PREVOST

WARRANTY BULLETIN

WB23-37

DATE:	December 2023	SECTION:	06 ELECTRICAL
EXPIRATION:	December 2025		
SUBJECT:	WIPER MOTOR HARNESS MODIFICATION

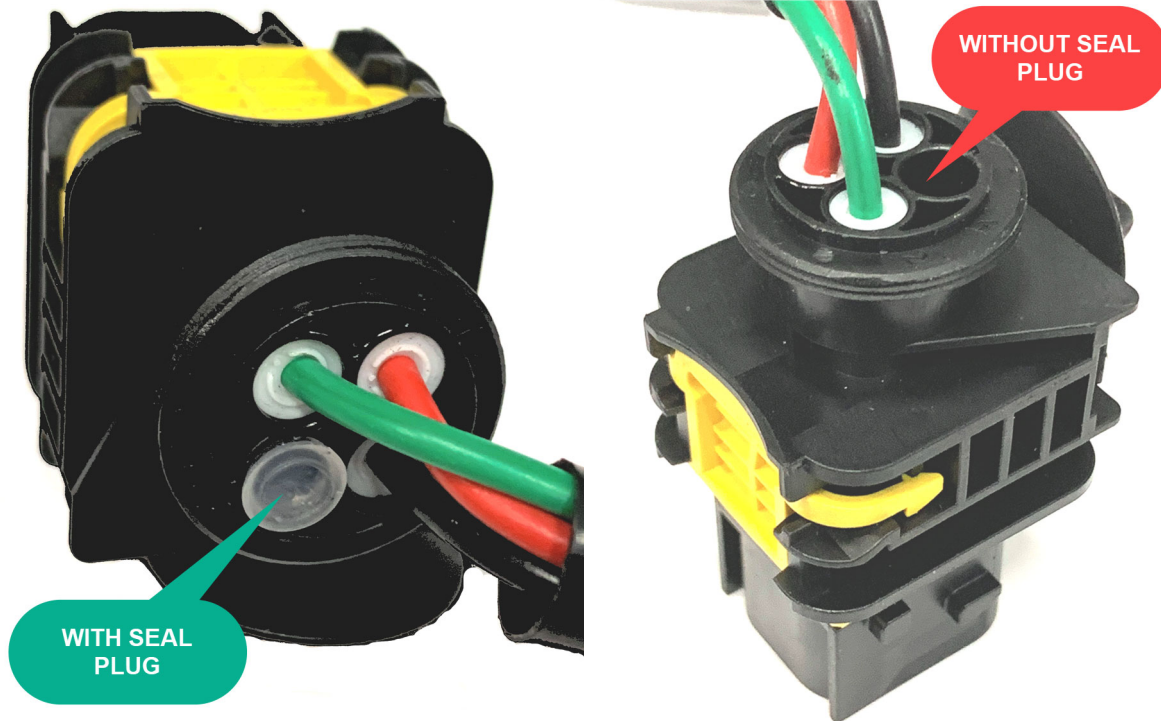
4. Locate the connector of the wiper motor.

5. Verify if the connector has a plug into the empty cavity.
- If no, go to the next step.
 - If yes, the procedure is complete.

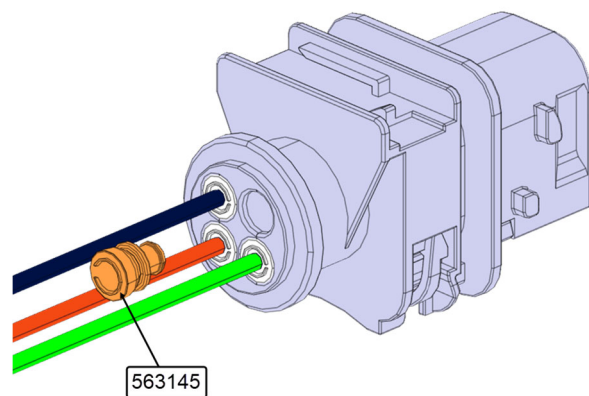
On the vehicles affected by this bulletin, the wiper motor harness needs a modification to avoid connector terminals corrosion.

6. Add cavity plug 563145 to connector empty terminal hole.
